**Re: Route 133 Pump Station Improvement Project
Brookfield Water Pollution Control Authority
Brookfield, CT
Addendum No. 1
Langan Project No.: 190011048**

You are hereby notified of the changes and clarifications below to the Construction Document set for the above-referenced project. The Construction Document set shall be amended as follows:

Project: **ROUTE 133 PUMP STATION IMPROVEMENTS**

Drawing Title: **PUMP STATION IMPROVEMENT PLAN**

Project No.: 190011048
Drawing No.: CS101

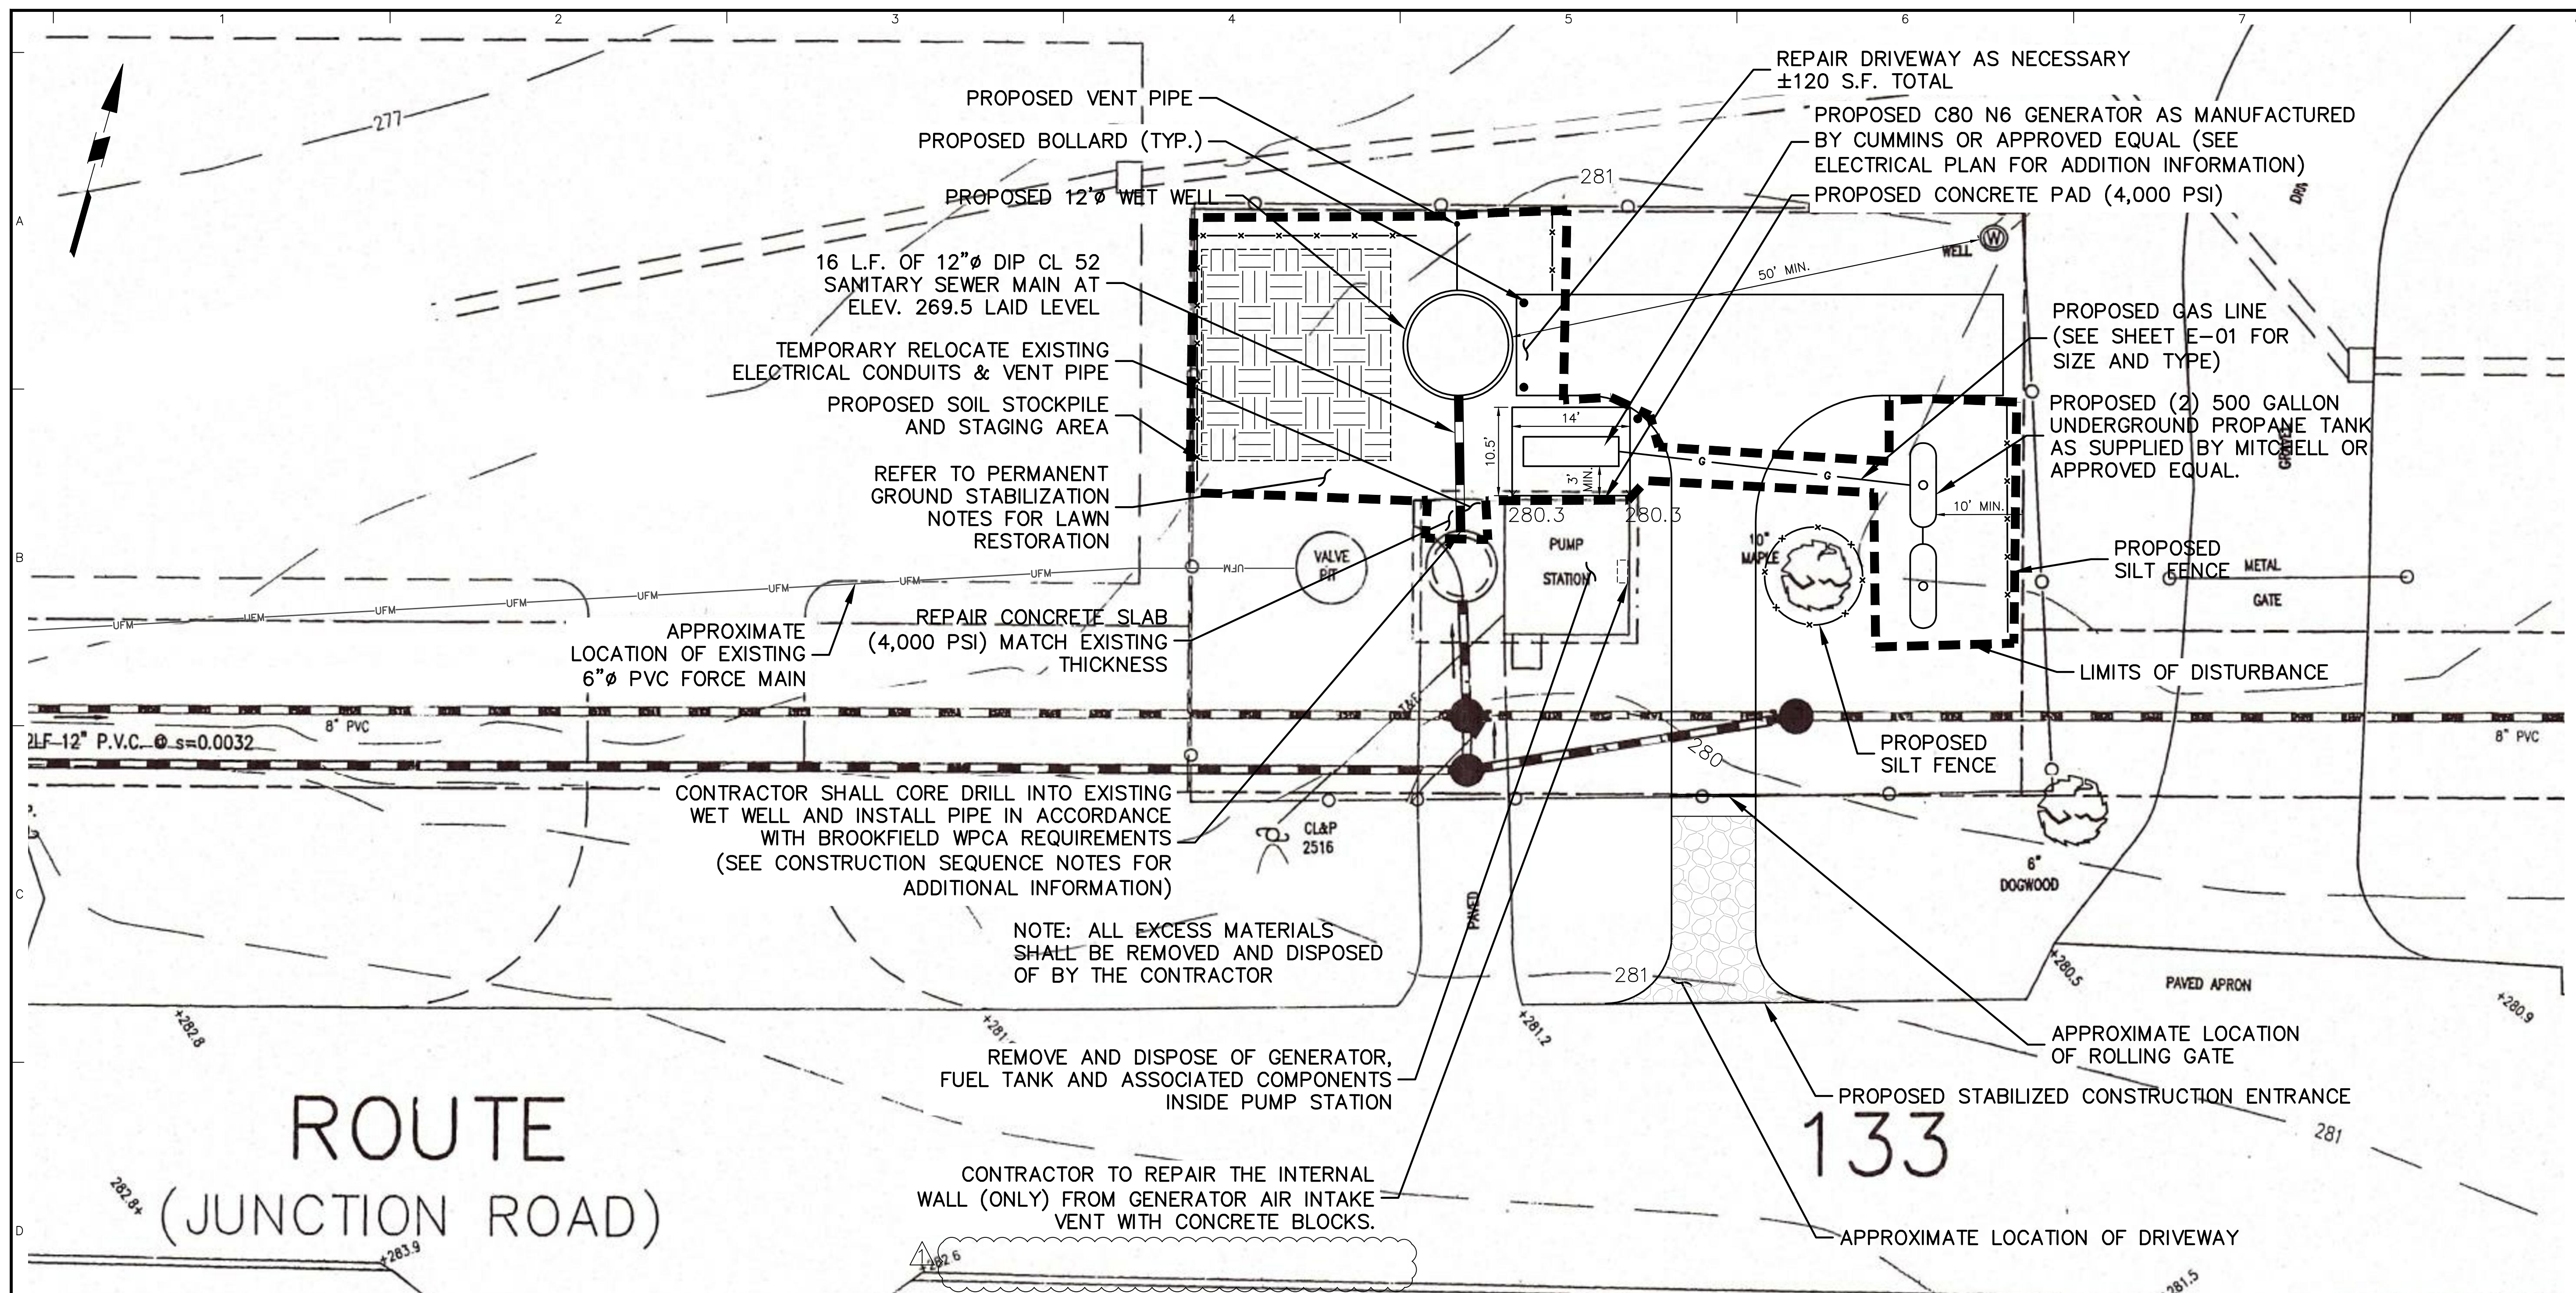
1. The construction drawings have been revised to address the following changes:
 - Sheet CS101, Remove note which states contractor shall paint concrete blocks (match existing).
 - Sheet CS501, 12-foot diameter wet well detail has been revised to state the 12-inch DIP CI 52 connector pipe between existing and proposed wet well.
 - Sheet E-02, LP Storage Tank Installation Detail, has been revised to show concrete anchors. The LP Installation Notes have been revised.
2. Bid Sheet
 - Item 14, Repair Driveway quantity has been revised.
 - Item 24, Allowance for Rock has been added.
3. Contract Item
 - Item 14, Repair Driveway has been revised.
 - Item 24, Allowance for Rock has been added.

Question 11. On drawing CS101 there is a note to fill in the existing generator intake louver with masonry. At the pre-bid meeting the owner noted he did not want the existing louver removed. Please clarify how we are to infill the opening.

Response: The exterior louver will remain. The inside wall will be repaired with masonry blocks. The contractor is no longer responsible for painting the masonry blocks. Sheet CS101 has been revised to remove the note which states "contractor shall paint concrete blocks (match existing)."

12' DIA. WET WELL
SCALE: NTS

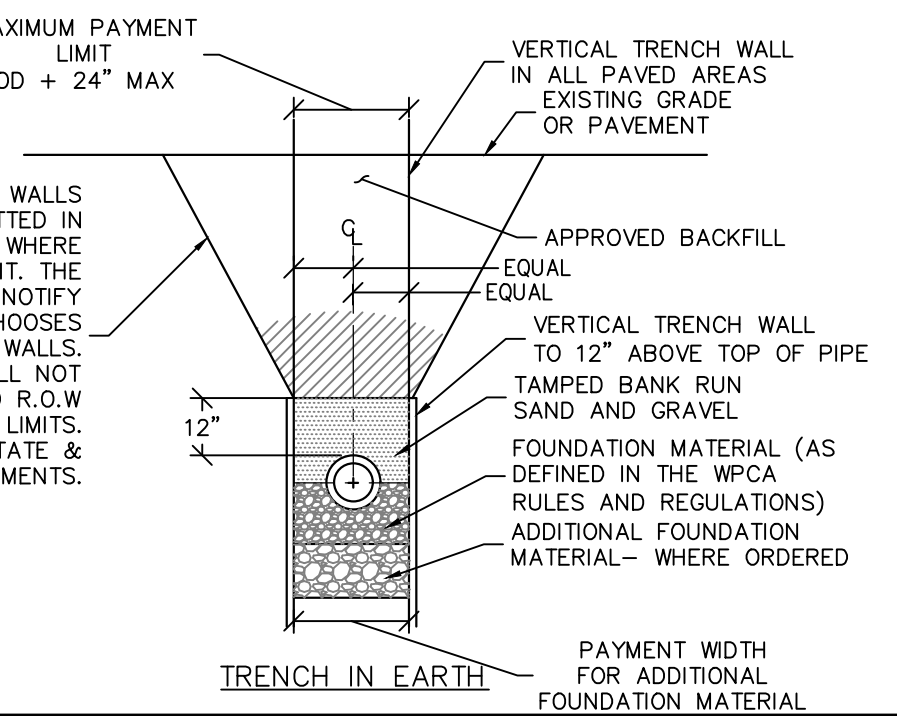
Question 7. Drawing CS101 details a new 12" diameter ductile iron pipe between the two wet wells and drawing CS501 details a PVC SDR 35 pipe. Please clarify which type of pipe is needed.

Response: **The wet well detail on Sheet CS501 has been revised to state the 12-inch DIP CL 52 pipe to connect the existing and proposed wet well.**

STABILIZED CONSTR. ENTRANCE
SCALE: NTS

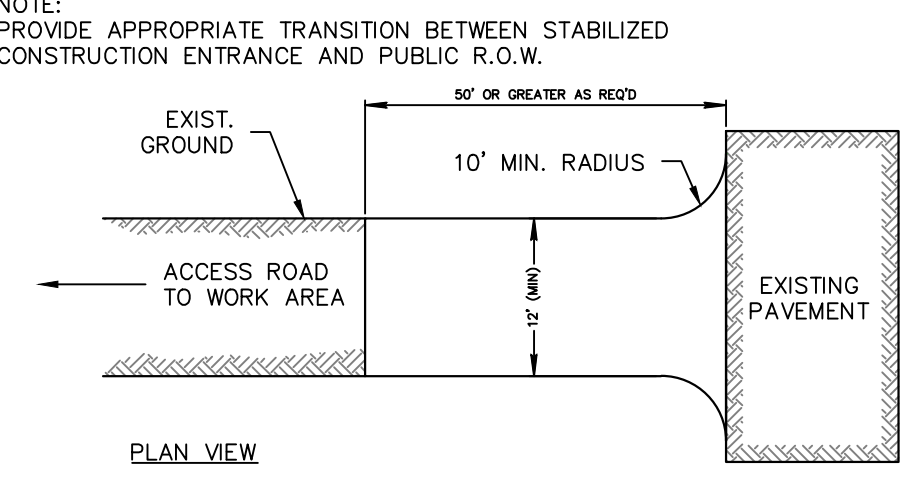
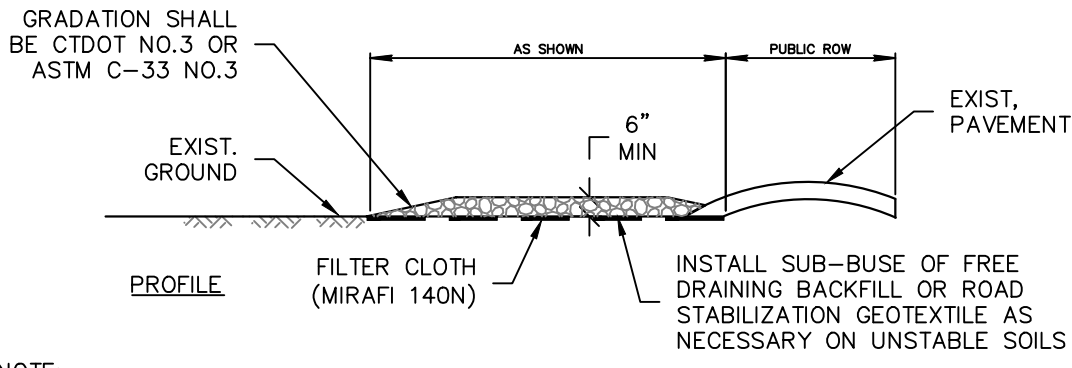
Question 6. The existing pump station is not paved, and it is a gravel base, do we have to install a new stabilized construction entrance on top of the existing gravel base as detailed on drawing CS501?

Response: **The contractor is required to keep the CTDOT Route 133 Road clean at all times. The contractor will be required to place the stabilized construction entrance if the road cannot be kept clean.**

Project No.	19001048	Drawing No.	E-02
Date	5/19/2020	Checked By	HRS
Drawn By	NM	Sheet	5 of 5

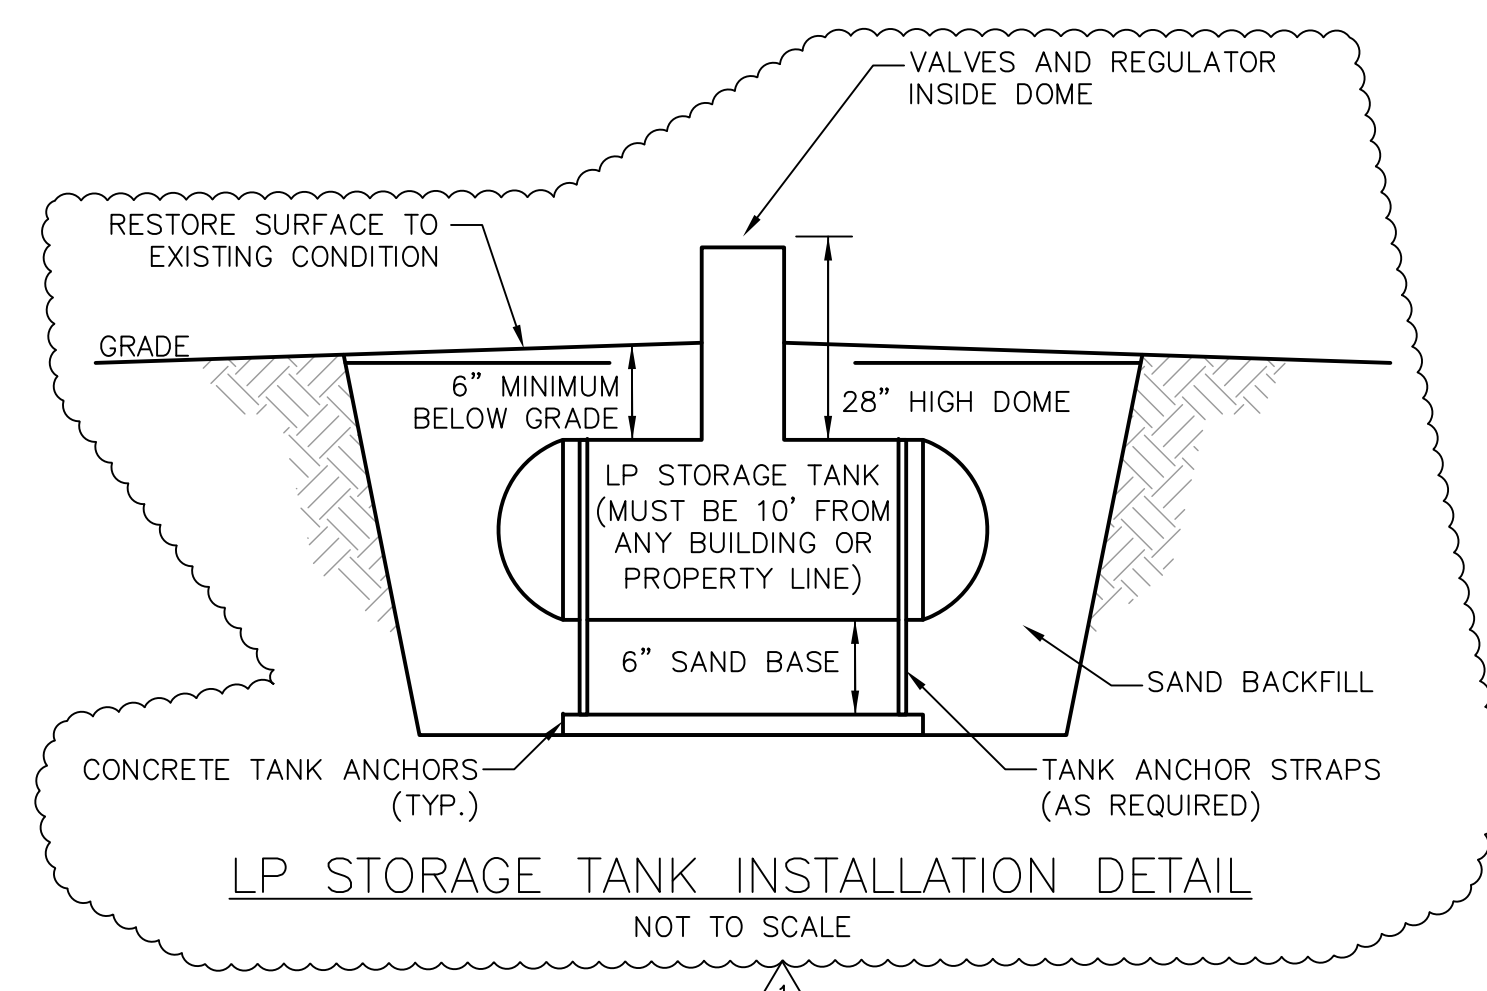
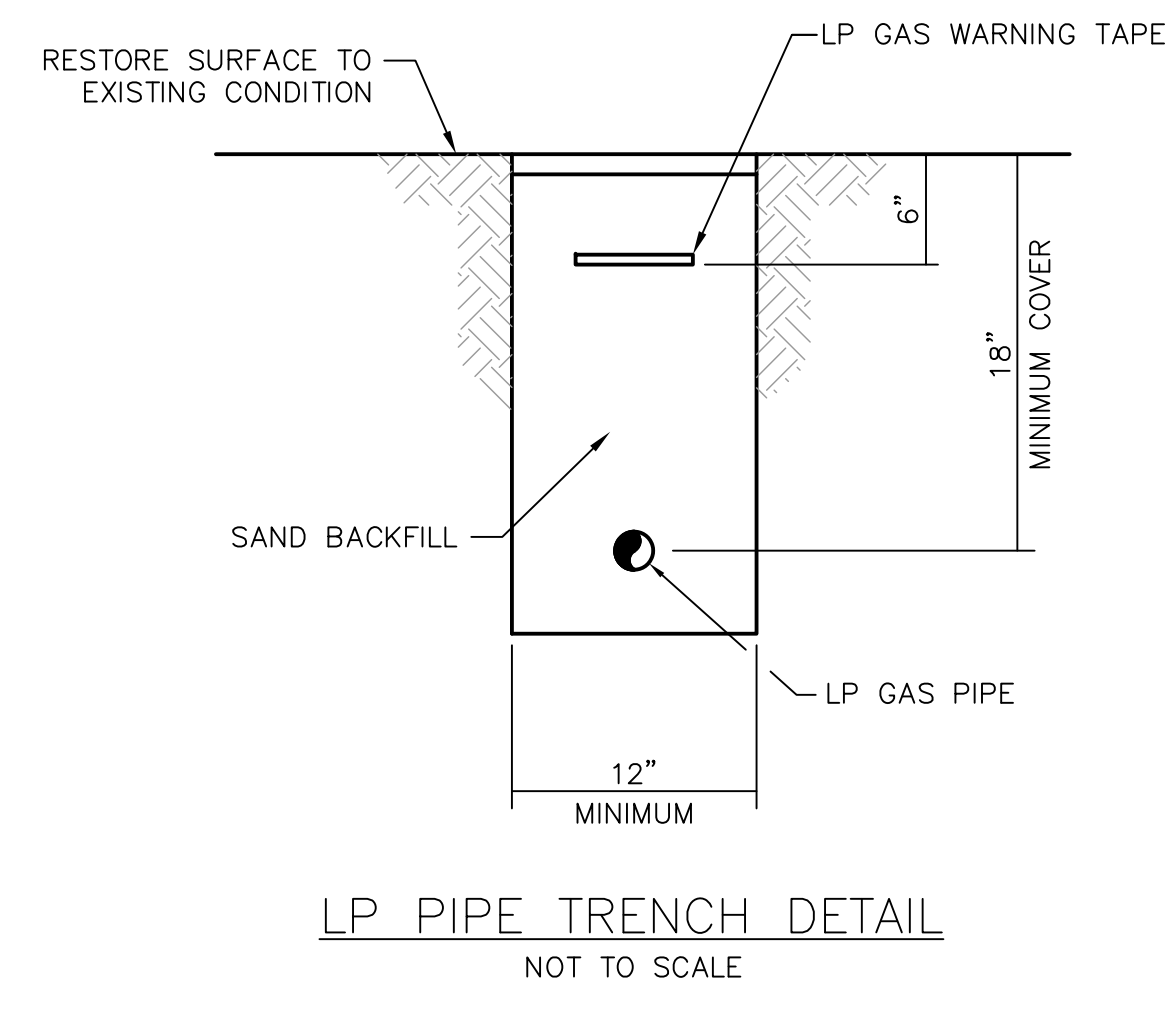
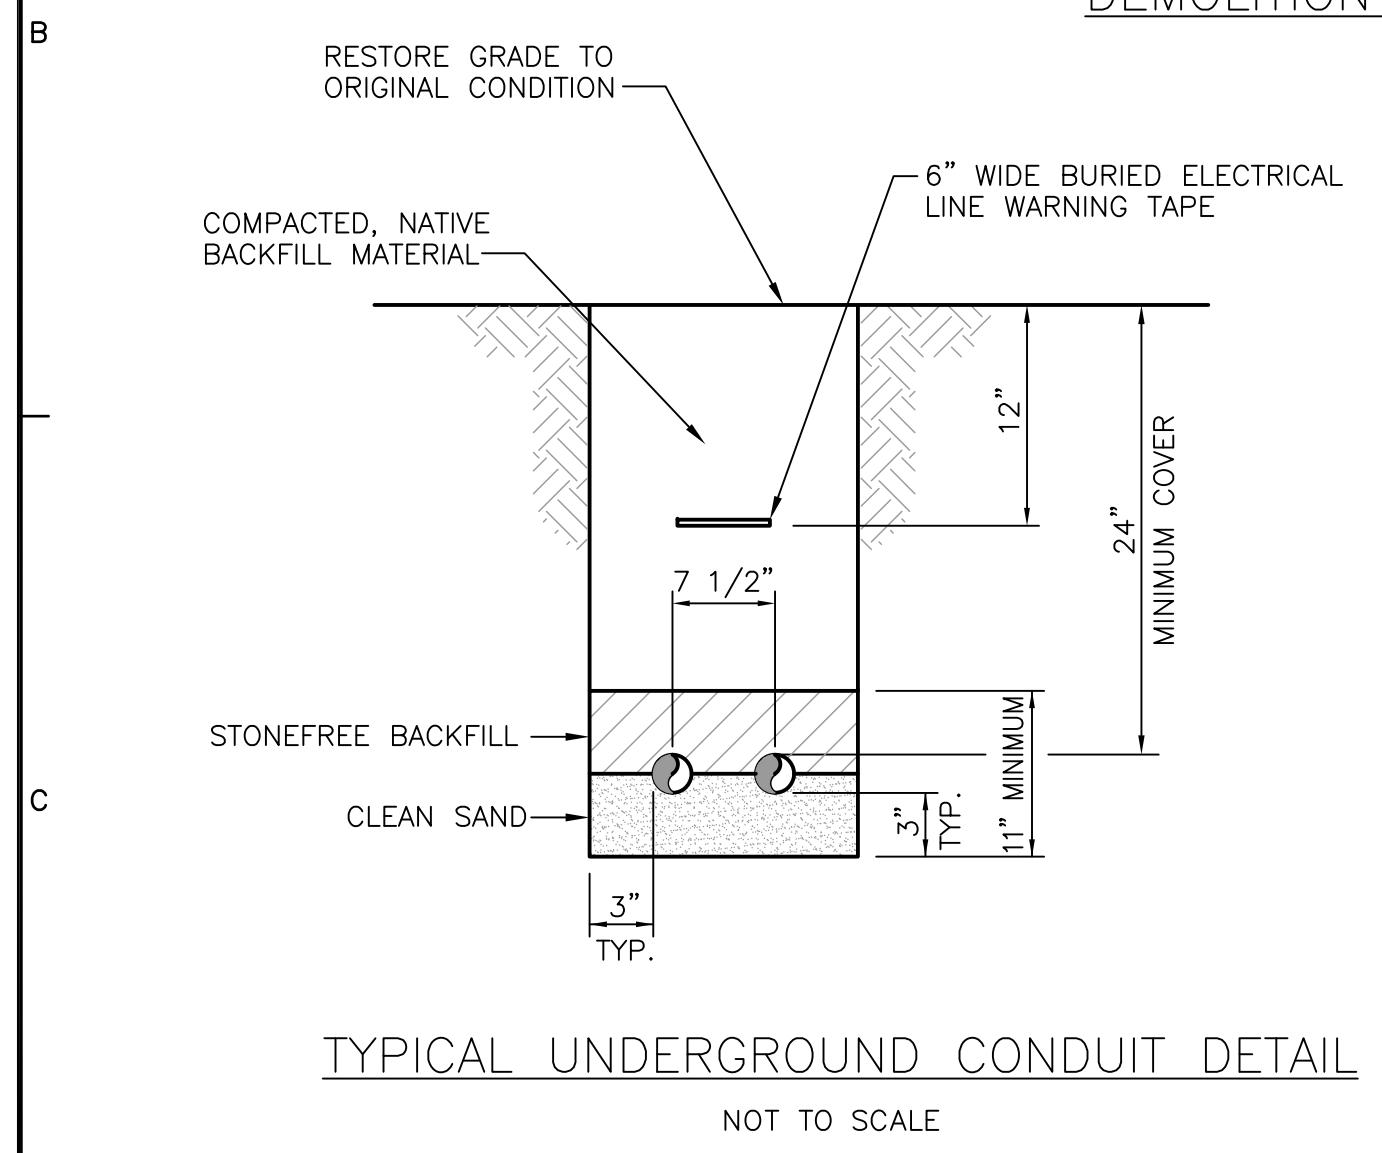
Question 3. Will the two new underground propane tanks require a concrete hold down slab or anchor?

Question 15. On drawing E-02 under LP installation notes, note # 1, it is noted to provide galvanized schedule 40 black iron for the underground pipe from the tanks to the generator. Mitchell company the specified propane installer wants to provide poly plastic gas line sleeved in plastic well pipe in place of the black iron pipe. Is plastic gas line acceptable? Mitchell claims this pipe arrangement is what they normally install for all the Brookfield generator projects.

Response: **Concrete anchors have been provided on Sheet E-02, LP Storage Tank Installation Detail. Refer to LP Installation Note # 3.**

Response: See revised LP Storage Tank Installation Note #1 on Sheet E-02 for clarification.

- LP INSTALLATION NOTES:**
- GAS PIPING SHALL BE SCHEDULE 40 BLACK STEEL PIPE OR APPROVED EQUAL FOR ALL INTERIOR AND UNDERGROUND INSTALLATIONS. ALL ABOVE GRADE, OUTDOOR INSTALLATIONS SHALL BE GALVANIZED SCHEDULE 40 BLACK STEEL GAS PIPING OR APPROVED EQUAL. UNDERGROUND PIPING SHALL HAVE 6" WIDE WARNING TAPE INSTALLED ABOVE GAS PIPING.
